Parkside Neighborhood Center & Affordable Housing

77 & 85 Grant Street

RE: PROP, Parkside Neighborhood Center and Affordable Housing, Portland, ME
CBL: 0486011

We've reviewed your comments forwarded via fax and also over the phone and offer the following explanations and supplemental information.

Design No. U357

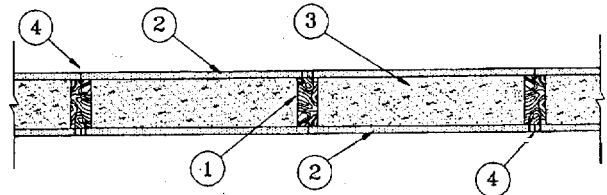
Building **B** to eastern Abutter - due to the proximity of our proposed building to the potential of an abutting building to the east, we will increase the fire assembly rating of the exterior wall along the eastern side to 1 hour per Table 705.2. I have attached the UL assembly that we intend to use.

Bearing Wall Rating — 1 Hr
Nonbearing Wall Rating — 2 Hr
